Errata

Title & Document Type: 8614A Signal Generator Operating and Service Manual

Manual Part Number: 08614-90001

Revision Date: March 1979

Figure 4-5. Pulse Modulation Circuit

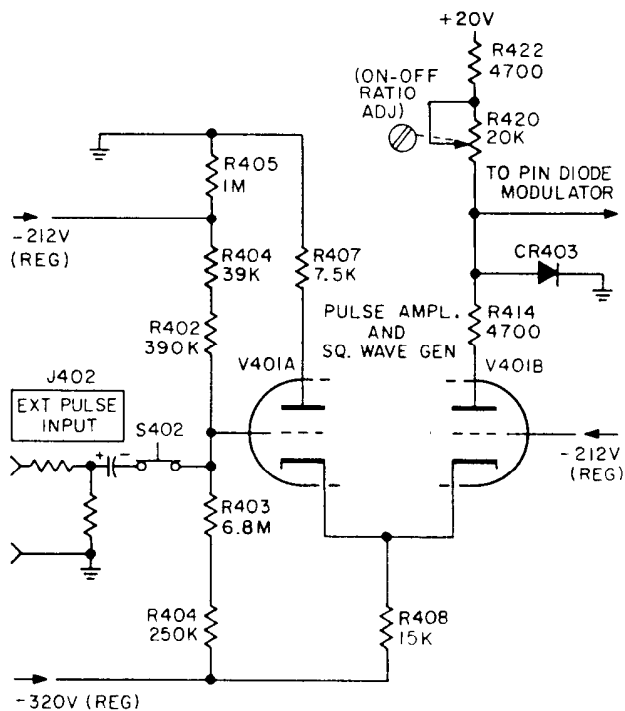
CHANGE I: Page 4-3, Figure 4-5,
R402: Change from 390K to 39K.
R403: Change from 6.8M to 470K.

Figure 5-2. External Pulse Check (P/O Errata)

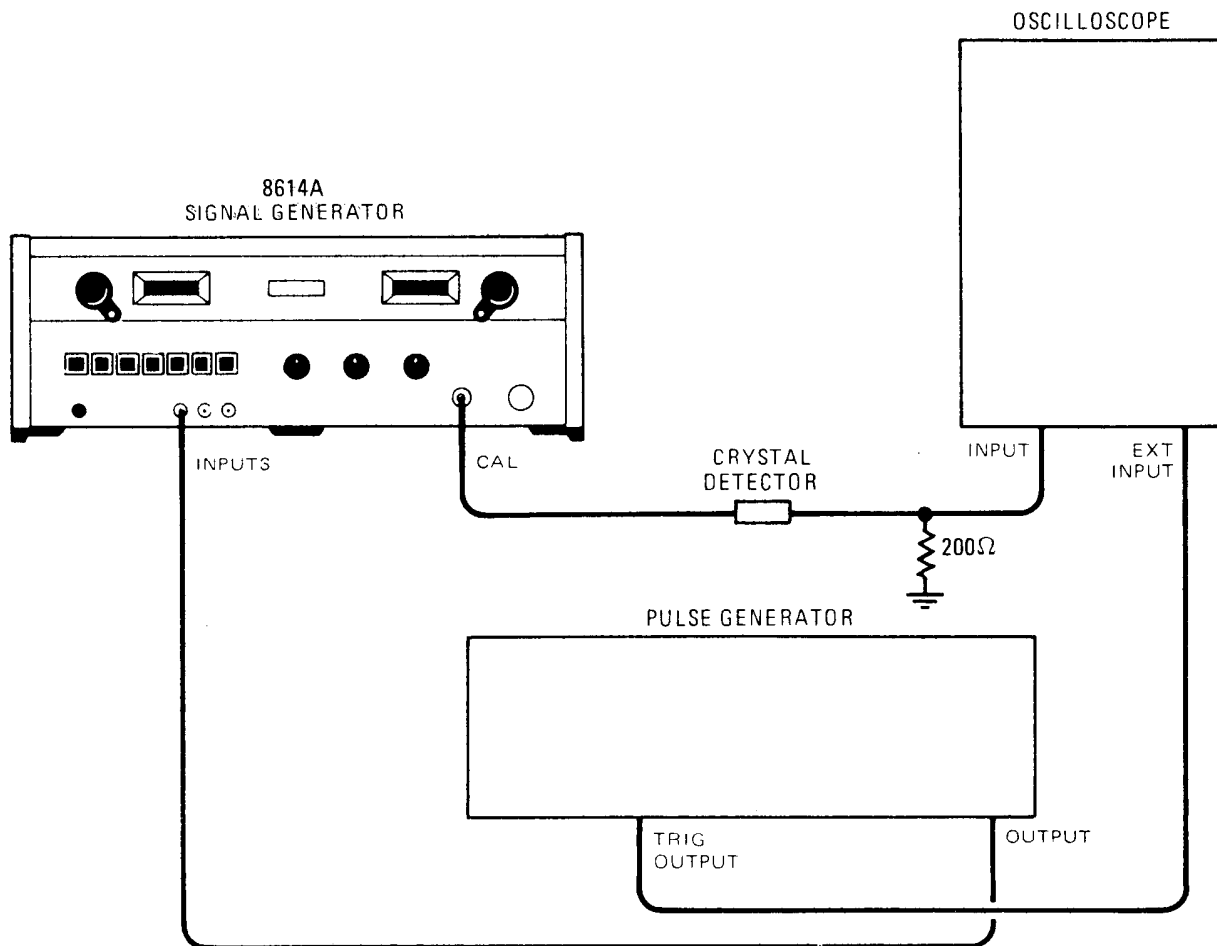
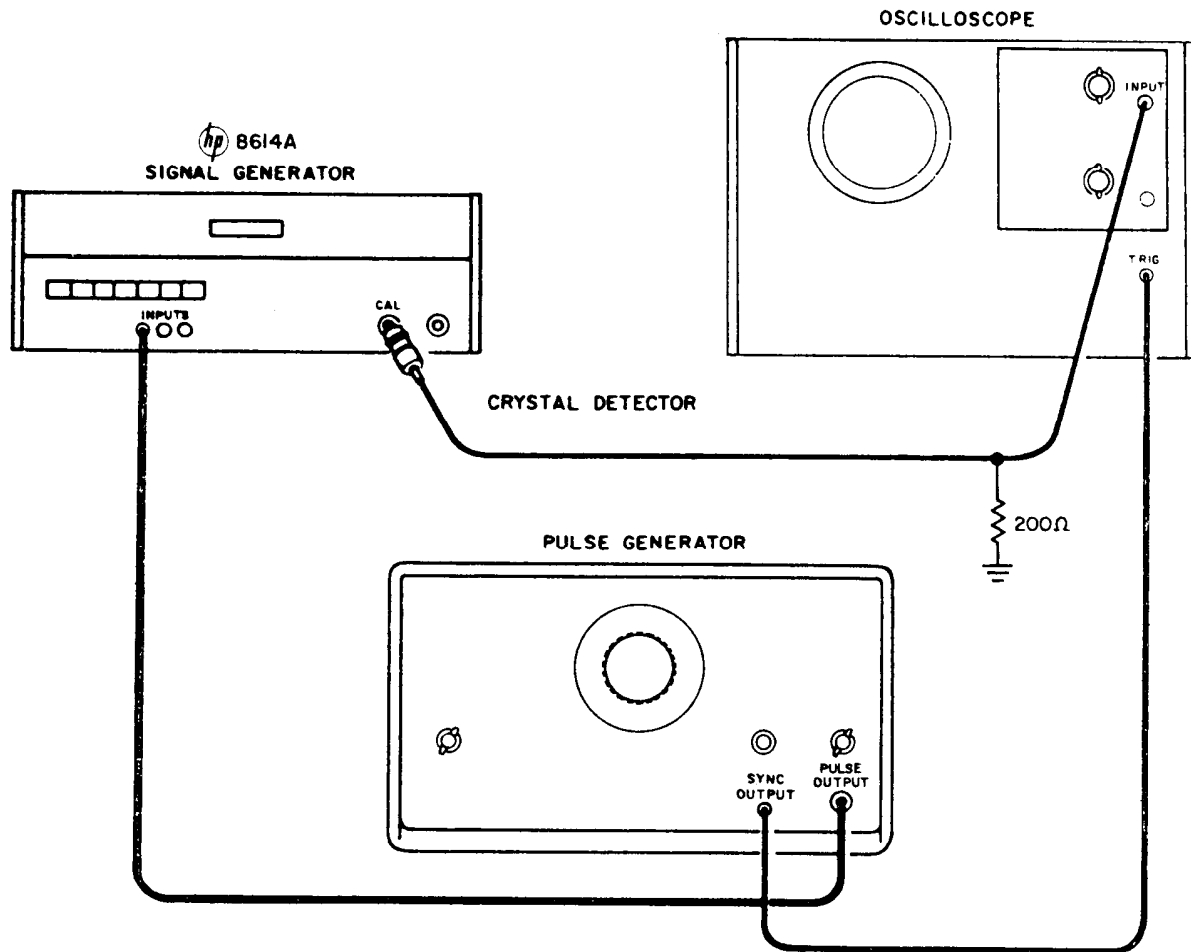
* Page 5-2, Figure 5-2:
 Replace Figure with attached Figure 5-2.

Figure 5-4. External AM Check (P/O Errata)

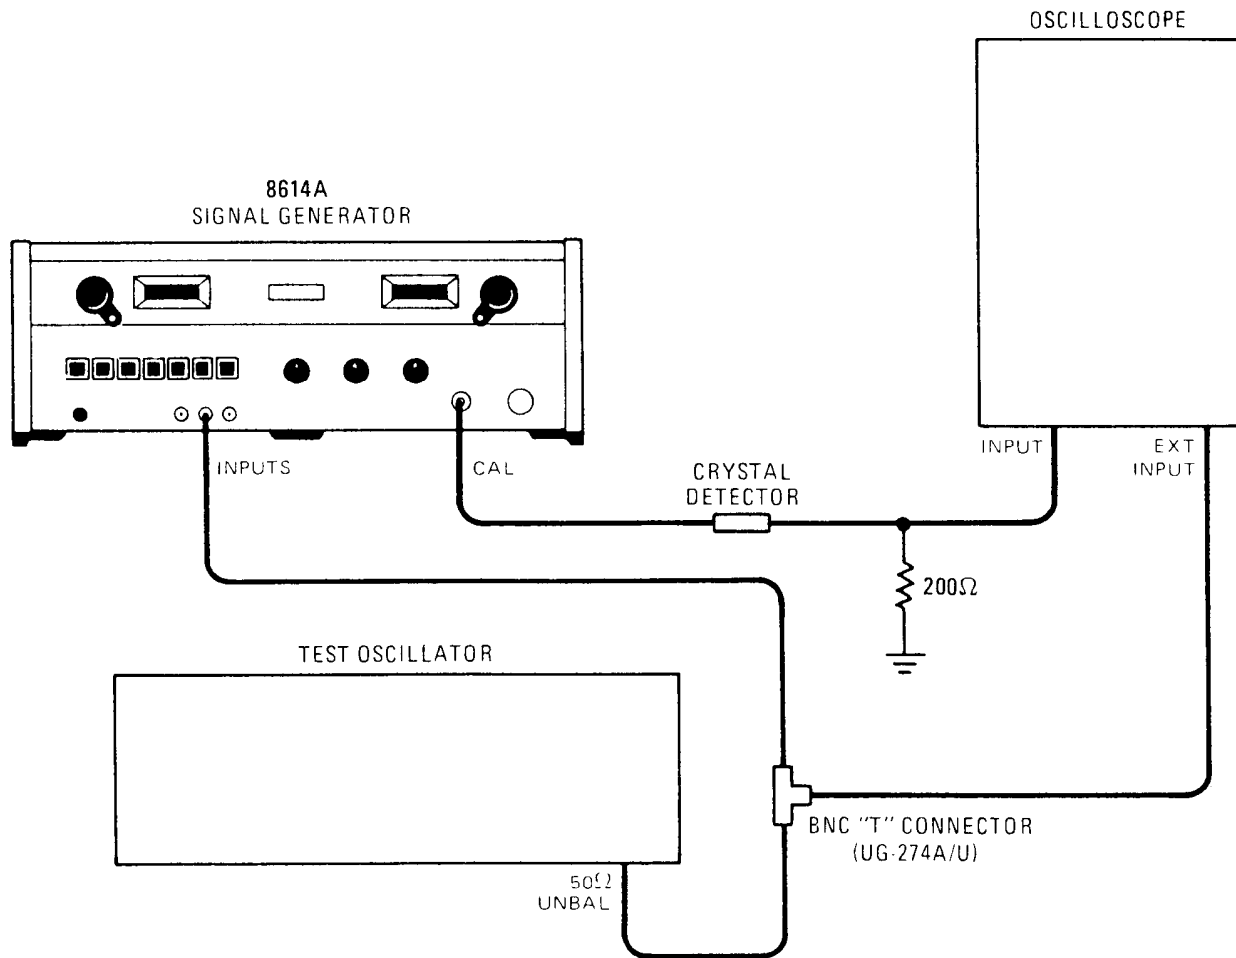
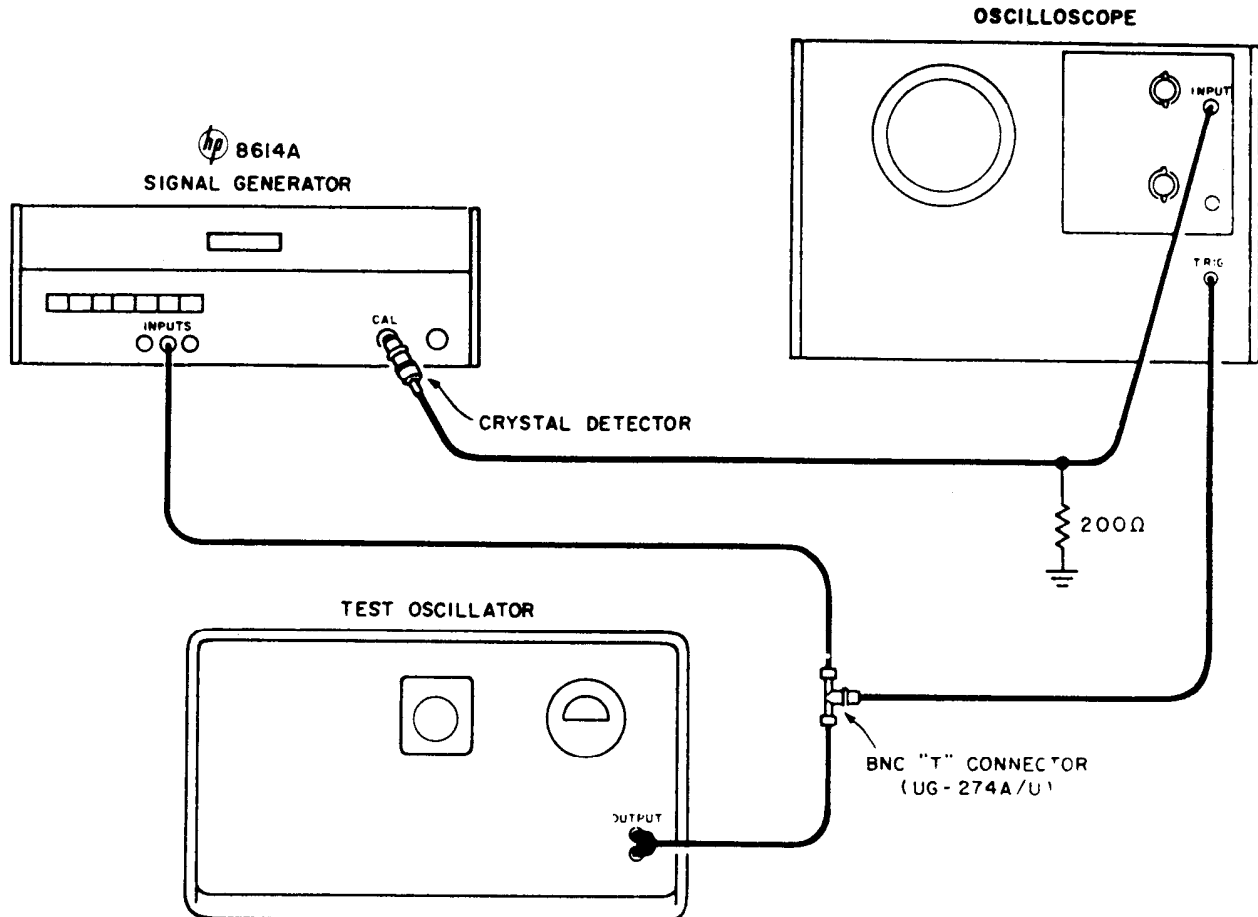
*Page 5-4, Figure 5-4:

Replace figure with attached Figure 5-4.

Figure 5-7. High-Voltage Test Point Location

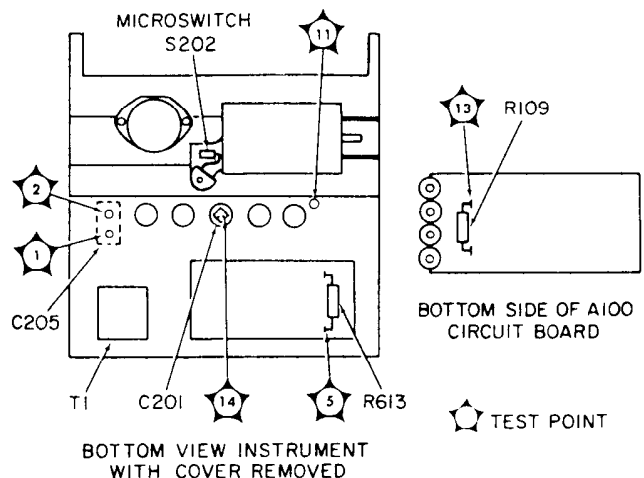
Figure 5-7, High Voltage Test Point Location,
 Delete test points 1 and 2 and C205. Note that test points 1 and 2 and C205 are shown in Figure 1.

Figure 5-10. RF Probe Assembly (P/O Errata)

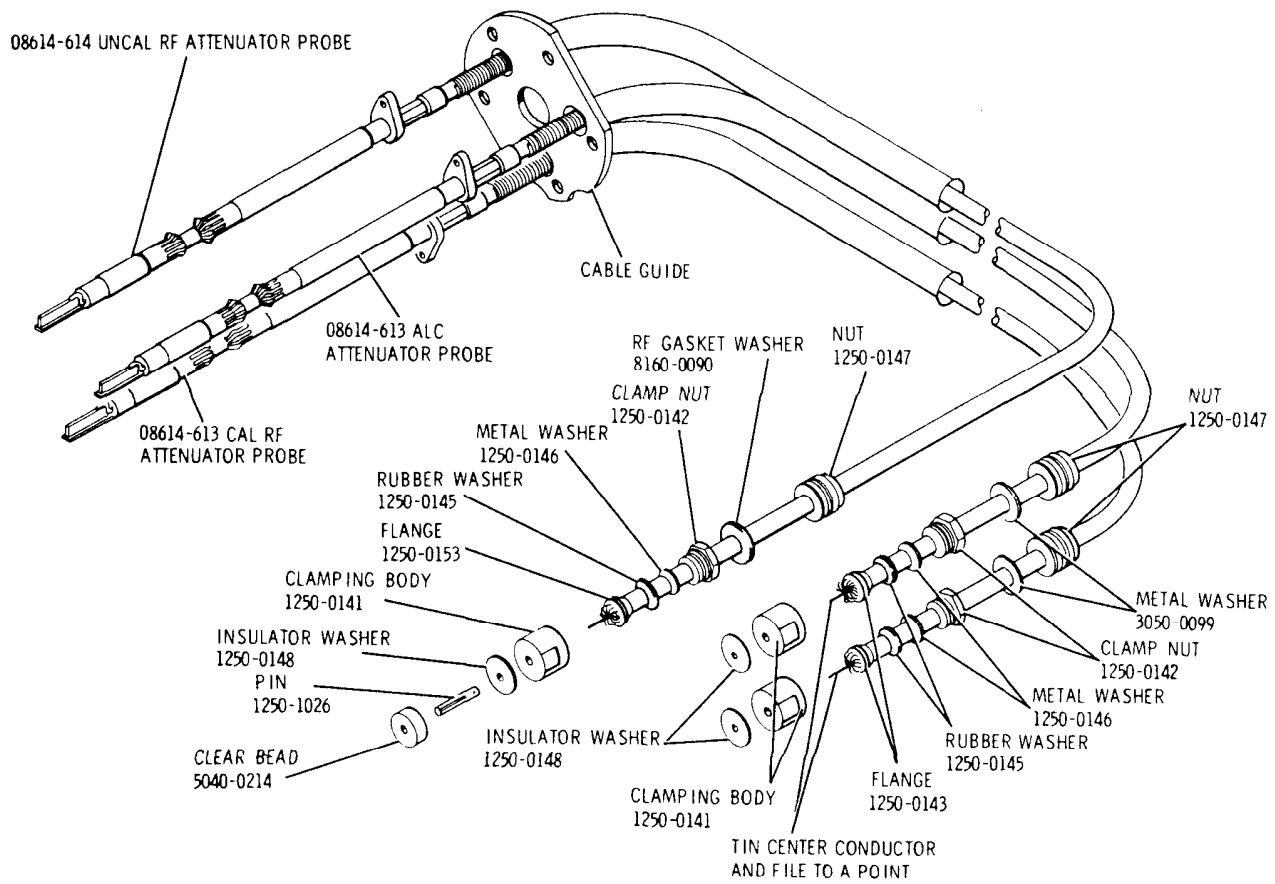
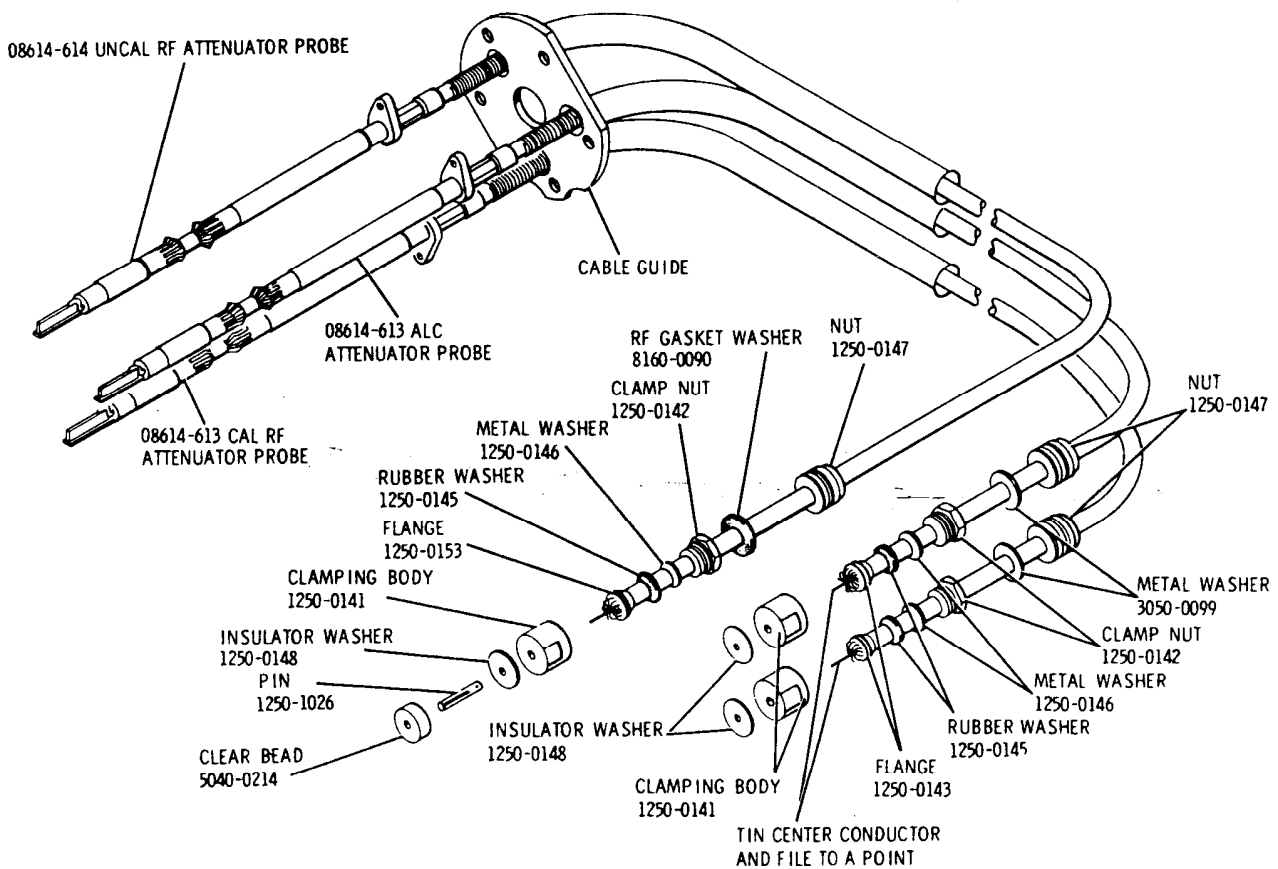
*Page 5-13, Figure 5-10:

Replace figure with attached Figure 5-10.

Figure 5-13. Instrument Top View, Cover Removed (P/O Errata)

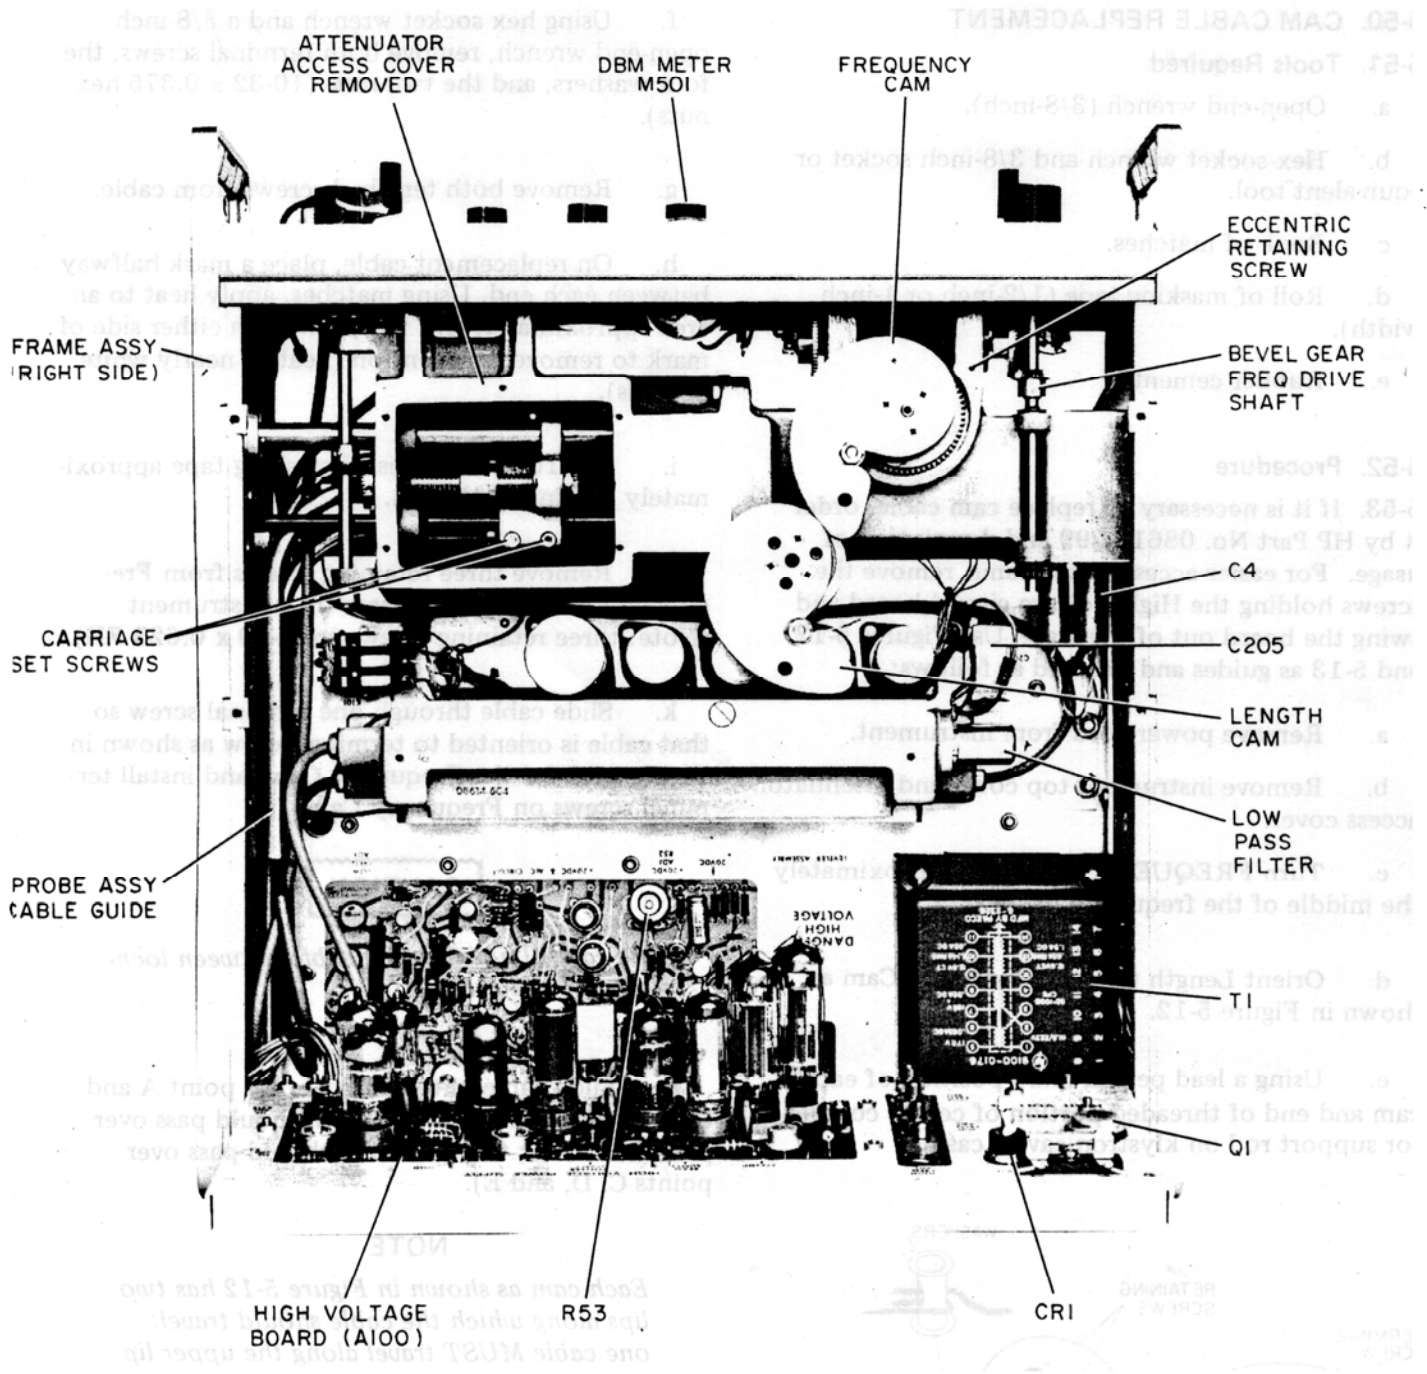
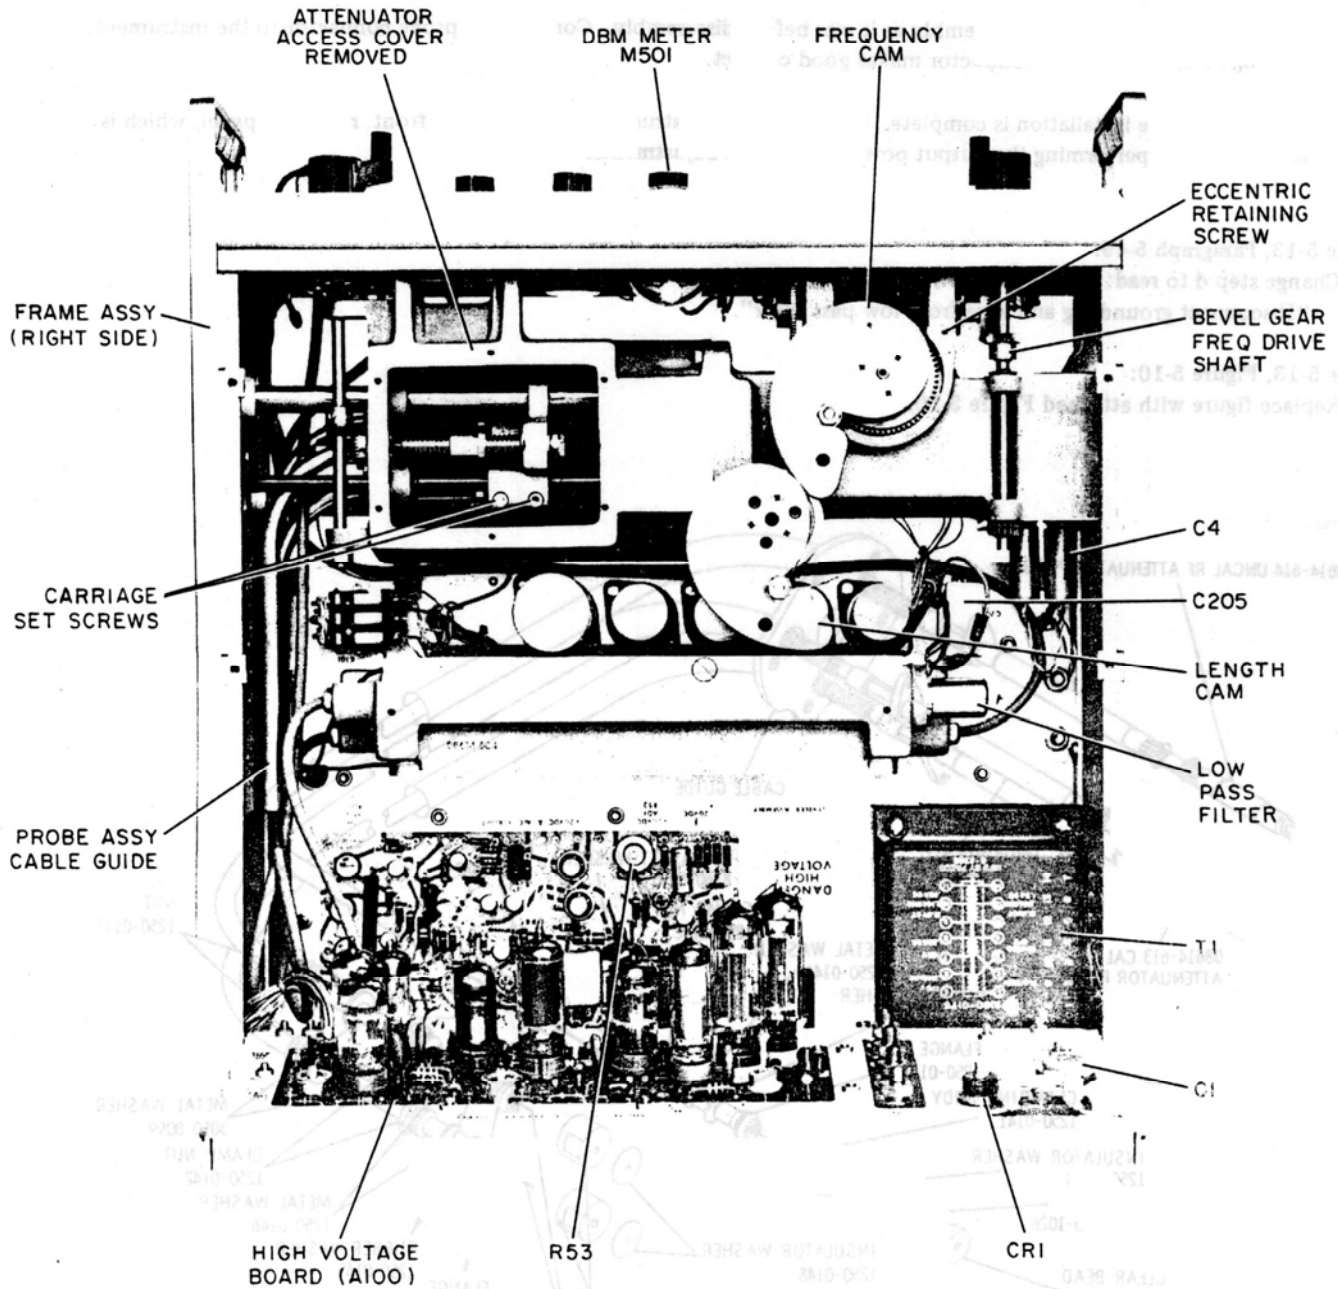
Page 5-15, Figure 5-13:

Replace figure with attached Figure 5-13.
